**Class II Permissive Change for
FCC ID: 2ADQJ-YSP88459SM / IC : 28512-YSP88459SM**

Model : BWR-YSP88459-SMA-LGA

Variant Difference

#. Filter change of only Bluetooth path

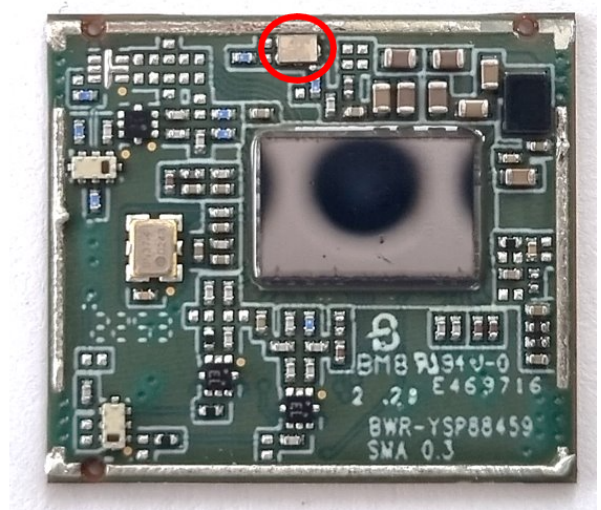
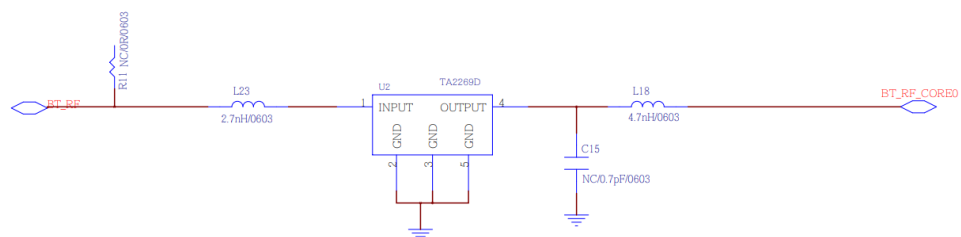
The reason for this update is the dualization of the component vendor. Consequently, a change has been implemented by amending the SAW filter within the Bluetooth pathway. new component has similar RF characteristics with previous component. All of other components are unchanged.

TA2269D ----> TA1834C
